Merged Document Report

Application No.: PL8504

Plat of Roy Smith Plaza Block 1, Lot 8

**Preliminary Utility Map of
 Roy Smith Plaza
 Block 1, Lot 8**

Preliminary Storm Water Quality Management Plan of Roy Smith Plaza

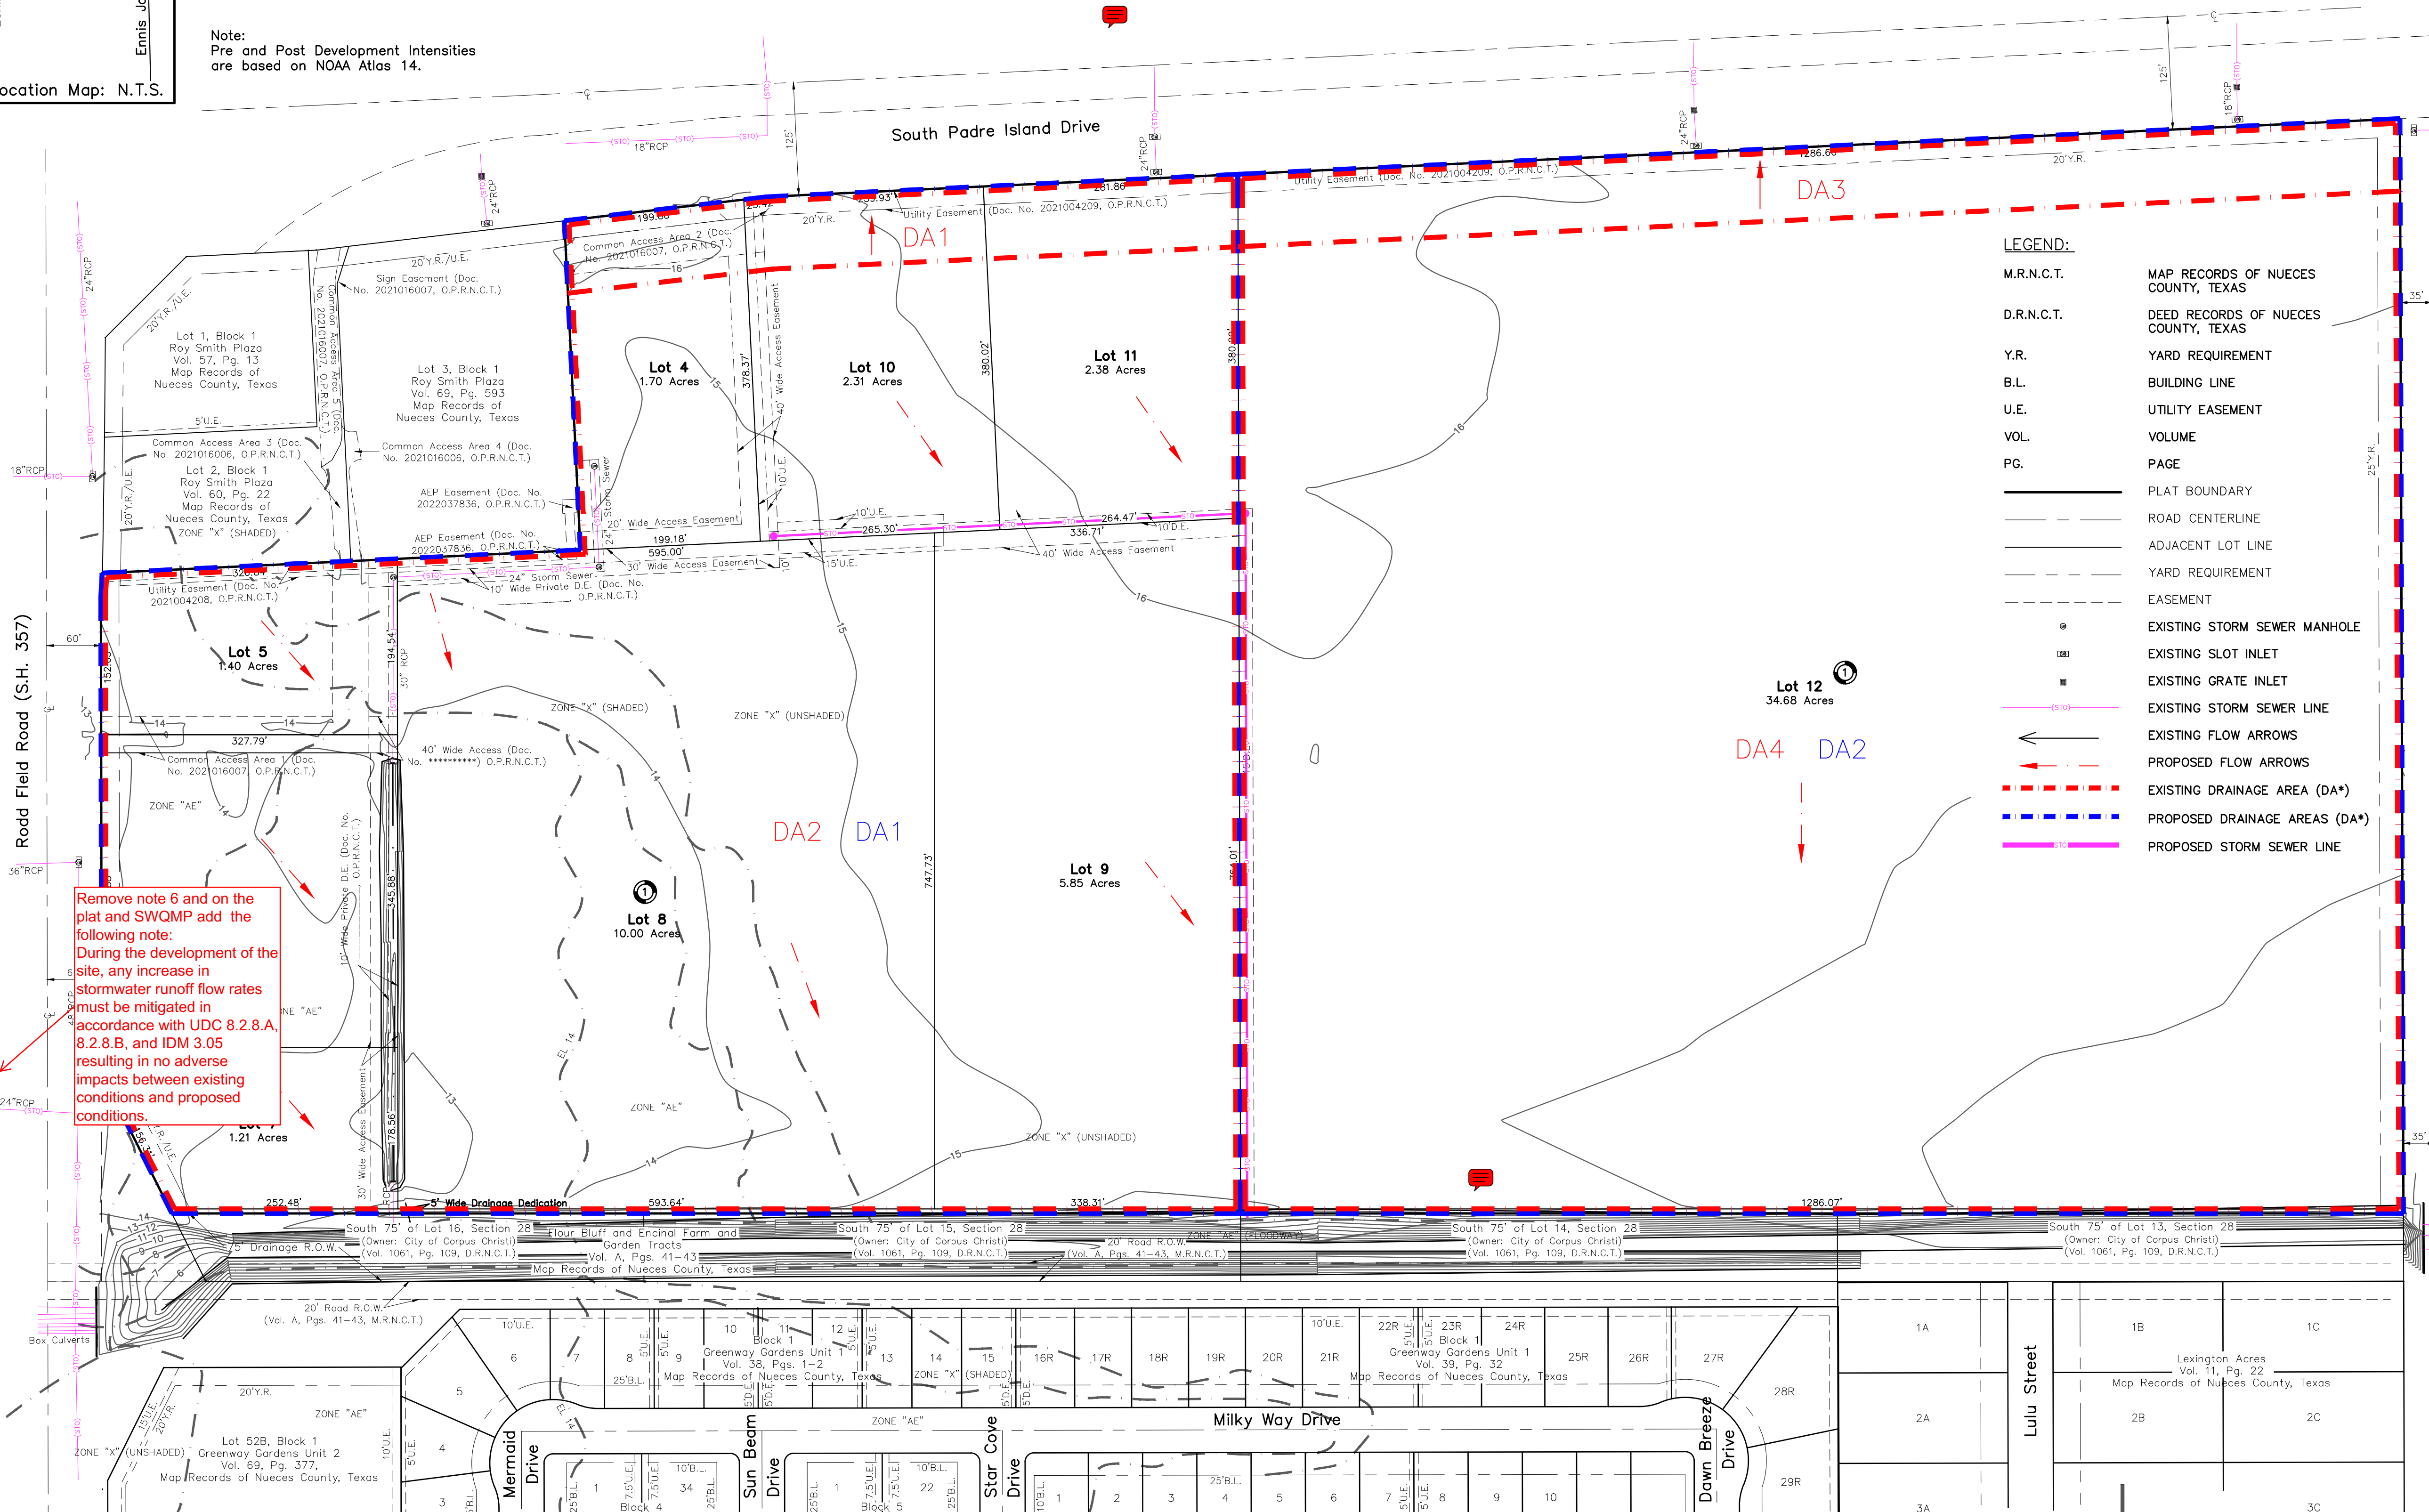
19	SWQMP	Note	Alex Harmon : DS	Open	<p>TXDOT: •No increase in storm water discharge to State right-of-way shall be accepted by TxDOT.</p> <p>•TxDOT Permits will be issued in accordance with the access management standards and all applicable state and federal laws, including rules and regulations. Access connection spacing, materials, geometrics, accessibility, and other design specifications will be considered, as well as the impact on drainage and hydraulics, utility location or relocation, and the environment that will result from the requested construction of an access connection. 43 Tex. Admin. Code § 11.52 (2020).</p> <p>•Drainage improvements shall accommodate runoff from the upstream drainage area in its anticipated maximum "build-out" or "fully developed" condition, and shall be designed to prevent overloading the capacity of the downstream drainage system</p> <p>•If the owner responsible for maintenance of the permanent stormwater or water quality control fails to maintain the control to TXDOT ROW, the owner shall correct the problem.</p>

Remove note 6 and on the plat and SWQMP add the following note:
During the development of the site, any increase in stormwater runoff flow rates must be mitigated in accordance with UDC 8.2.8.A, 8.2.8.B, and IDM 3.05 resulting in no adverse impacts between existing conditions and proposed conditions.
